Project	<b>IEEE 802.16 Broadband Wireless Access Working Group</b> < <a href="http://ieee802.org/16">http://ieee802.org/16</a> >	
Title	<b>Correction in PUSC Renumbering Formula</b>	
Date Submitted	<b>2004-08-27</b>	
Source(s)	Sean Cai Wenzhong Zhang Jing Wang Jason Hou Jun Han Dazi Feng Irving Wang  ZTE San Diego Inc. 10105 Pacific Heights Blvd. San Diego, CA 92121 USA	<a href="mailto:scai@ztesandiego.com">scai@ztesandiego.com</a> <a href="mailto:wzhang@ztesandiego.com">wzhang@ztesandiego.com</a> <a href="mailto:jwang@ztesandiego.com">jwang@ztesandiego.com</a> <a href="mailto:jhou@ztesandiego.com">jhou@ztesandiego.com</a> <a href="mailto:jhan@ztesandiego.com">jhan@ztesandiego.com</a> <a href="mailto:dfeng@ztesandiego.com">dfeng@ztesandiego.com</a> <a href="mailto:iwang@ztesandiego.com">iwang@ztesandiego.com</a>  Voice: 858-554-0387 Fax: 858-554-0894
Re:	Response to the call for contributions to IEEE Standard 802.16-2004, IEEE 802.16maint-04/01, 2004-08-04. Header error fix to IEEE 802.16maint-04/08.

## Correction in PUSC Renumbering Formula

Figure 1. 3-sector cell deployment

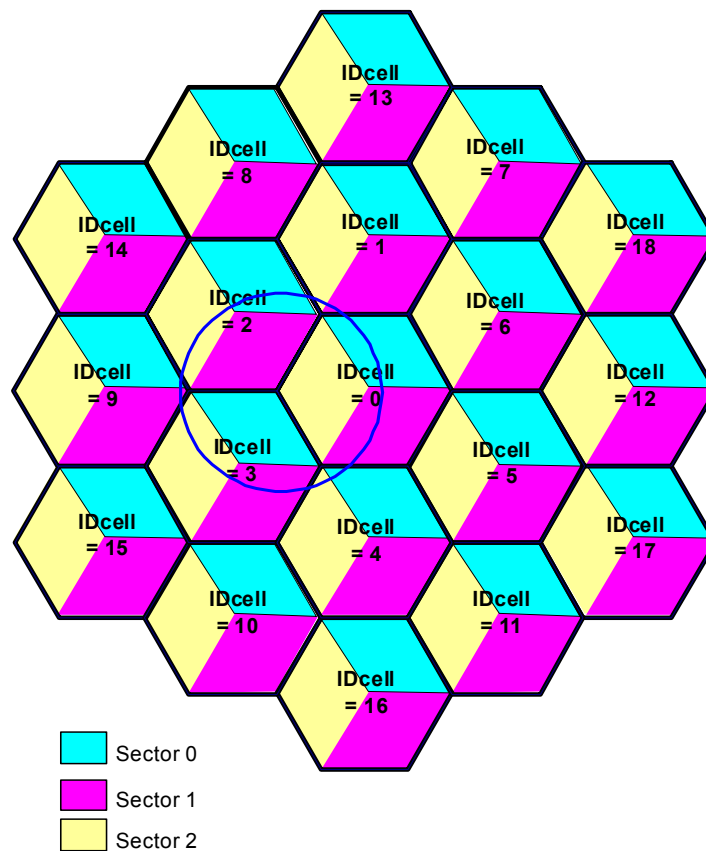
Here provided is an example of typical multiple 3-sector cell deployment, as shown in Figure 1 (circled in blue). The physical cluster numbers in red are the common physical clusters that will cause interference among these sectors.

Physical Clusters (Sector = 2, IDcell = 0):

114 **3** 92 **80 55** 88 **41** 98 94 **100 70** 64 **68 11** 118 25 **110** 62 **33** 84 5 **43**  
66 **112**

Physical Clusters (Sector = 1, IDcell = 2):

39 77 **100** 26 79 **55** 53 **43** 35 18 **110** 51 30 4 106 61 **41** 57 **112** 63 **33**  
82 27 **11**

Physical Clusters (Sector = 0, IDcell = 3):

**80** 9 74 58 78 **3** 81 107 **68** 7 95 52 60 **70** 72 36 103 117 34 56 15 24  
113 101

Based on the interference caused by the renumbering formula, we propose to remove the formula, using the only default renumber sequence in *Table 308* of IEEE P802.16-REVd/D5-2004. With this change, the physical cluster assignment to the 6 cluster groups (Group 0 to 5) are fixed; all the different group number subcarrier allocation will be orthogonal to each other, with the same or different IDcell number assignment. The same example in Figure 1 (circled in blue) can be used here. There are no colliding physical clusters from different sectors.

The interference caused by the sectors with the same group numbers of different BS, typically from second tier cells (such as sector 0 of IDcell 12 BS to sector 0 of IDcell 0 BS, as depicted in Figure 1), can still be mitigated with the help of current subcarriers permutation scheme defined in the standard; sectors from different cells may have the same physical clusters however their logical subchannels can be different due to intra-group data subcarrier permutation based on different IDcell numbers.
